NOISE—WINDNOISE FROM THE “A” PILLAR AREA	Article No. 02-17-8

FORD: 2001-2003 MUSTANG

Figure 1 - Article 02-17-8

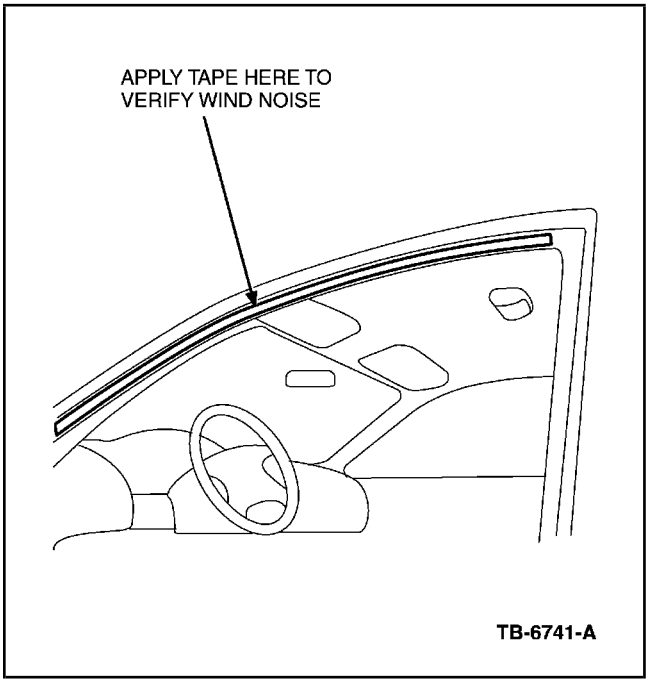
1. Verify windnoise by placing tape the length of the “A” pillar applique (roof moulding) on the door glass side (Figure 1).
2. Drive vehicle and verify that the wind noise is gone.
3. If the noise remains, do not continue with this article. Refer to Workshop Manual Section 100-04 for further diagnosis.
4. If the tape eliminates the noise, remove the tape and remove the A-pillar applique per the Workshop Manual (Section 501-08). Do not continue with the removal of the C-pillar trim.
5. Place foam block 2R3Z-63518C46-AA over third retaining hole in applique (Figures 2 and 3).
6. Re-install applique.
